River Junction Estates

Putnam, Connecticut

Environmental Review Team Report

for the
Inland Wetlands Commission
Putnam, Connecticut

Figure 4.

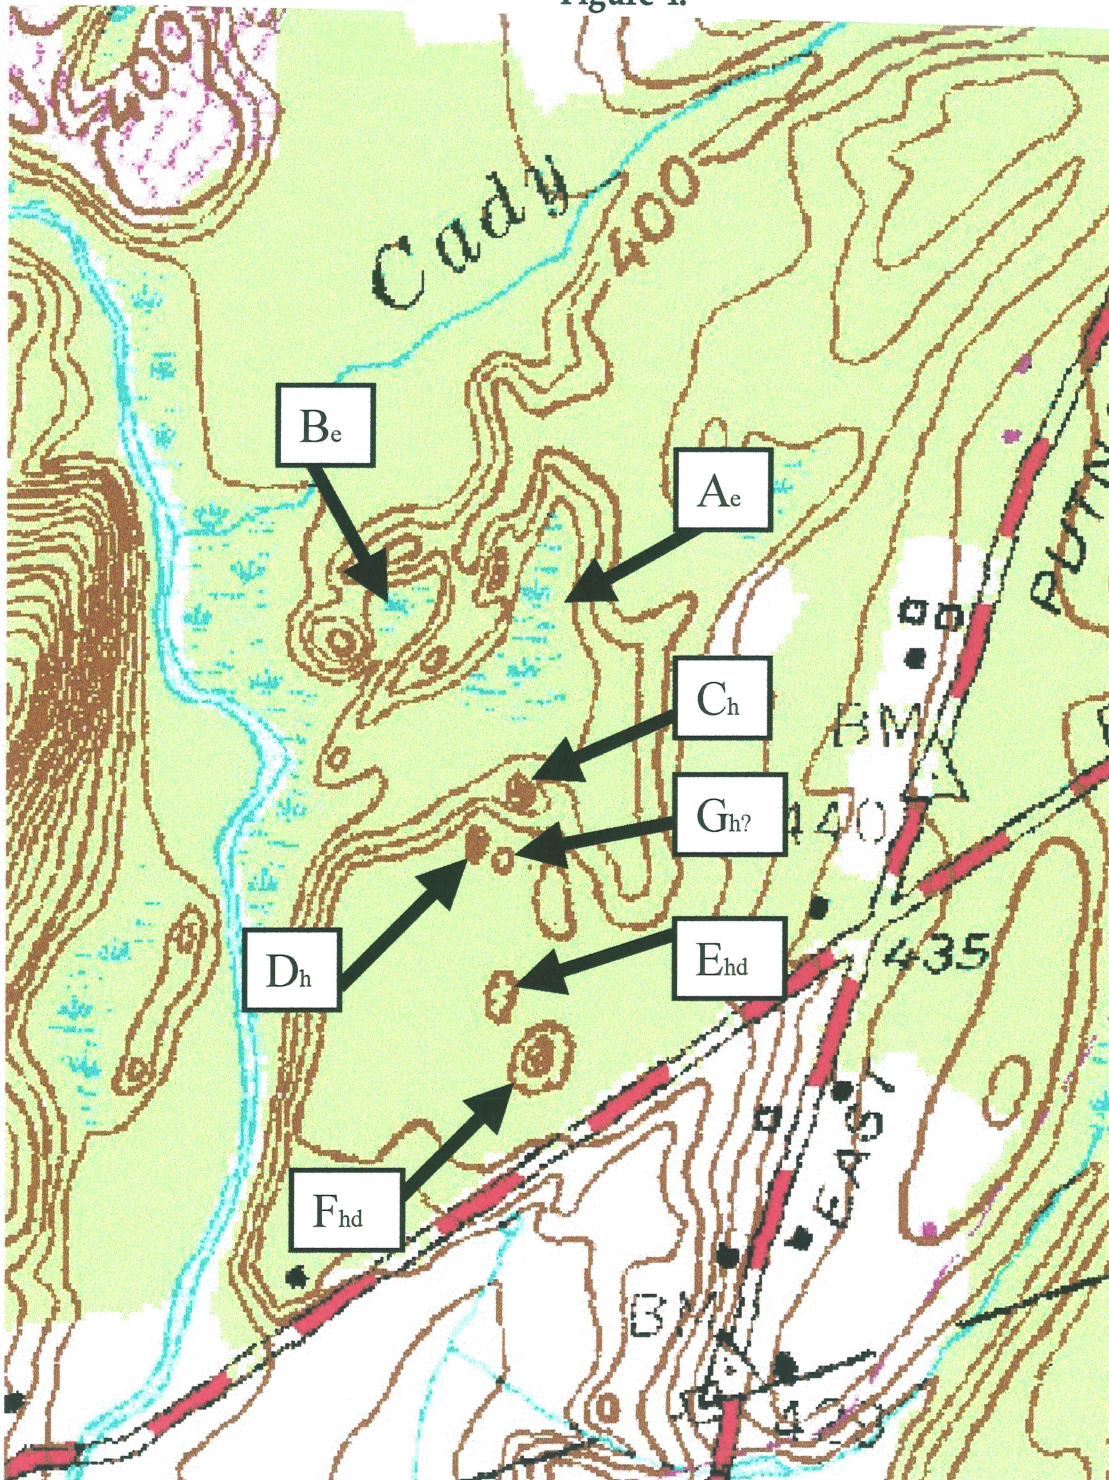
Pool A (please see Figures 4 and 5)

This pool is very roughly 1/2 acre in extent and is in a depression associated with an ephemeral surface watercourse along Ridgebury, Leicester, and Whitman soils. The pool is isolated from other surface water features, has no perennial surface inlet, and a narrow, channeled surface outlet at the south end that becomes subterranean distal to the pool. The pool is vegetated with a shrub zone of buttonbush (*Cephalanthus occidentalis*) more or less on the south end.

Pool B (please see Figures 4 and 5)

This pool is confined to the depression in a horseshoe-shaped glacial outwash feature. It is approximately 1/2 acre in extent and is vegetated with a shrub layer of chokeberry (*Pyrus Spp.*) and a benthic layer of sphagnum moss. Given the limited time and coverage at the field visit and especially that small portion afforded to this pool, this Team member noted no amphibians or aquatic invertebrates here. This has meaning only in the context of the previous qualifying statement; had time permitted, a more careful survey would likely have revealed the presence of one or more ephemeral pool indicators such as spotted salamanders.

To reiterate, the first and single most important thing is cessation of further disturbance to any remaining pools and their uplands. As noted, implementing the best *detailed* course of action for a plan to assist in restoration would require more focused assessments and prescriptions based on them.
